Docket No. 50-255

PALISADES PLANT

Amendment No. 21  
License No. DPR-20

ATTACHMENT TO LICENSE AMENDMENT NO.

PALISADES PLANT  
 CONTROL ROD INSERTION LIMITS  
 ALLOWED POWER LEVEL (% OF 2200 Mw) VS CONTROL ROD INSERTION (%) BY ROD GROUP  
 FOR OPERATION BELOW 1900 psia

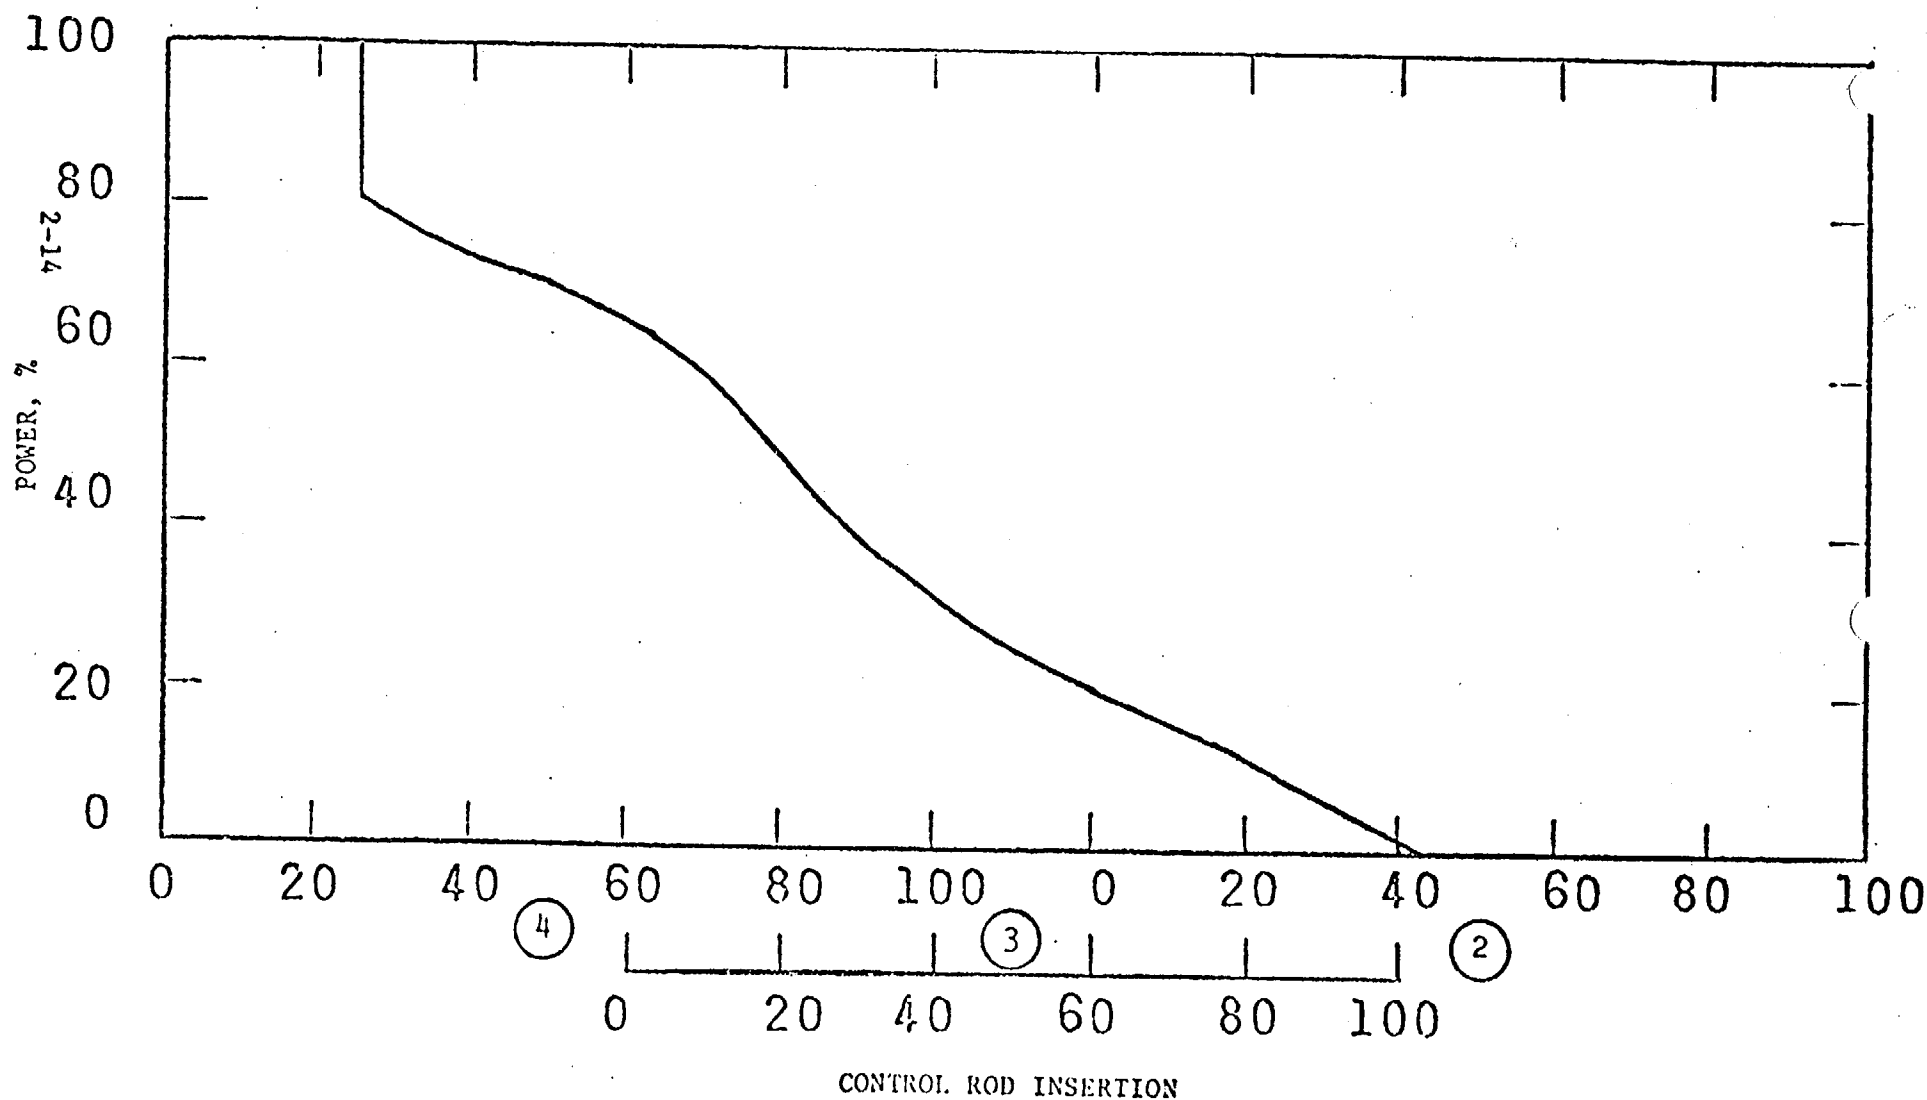
- a. To implement the limits on shutdown margin, individual rod worth and hot channel factors, the limits on control rod regulating group insertion shall be established as shown on Figure 3-6. These limits may be revised during fuel cycle life based on physics calculations and physics data obtained during plant start-up and subsequent operation.
- b. The sequence of withdrawal of the regulating groups shall be 1, 2, 3, 4.
- c. An overlap of control banks in excess of 40% shall not be permitted.
- d. If the reactor is subcritical, the rod position at which criticality could be achieved if the control rods were withdrawn in normal sequence shall not be lower than the insertion limit for zero power shown on Figure 3-6.
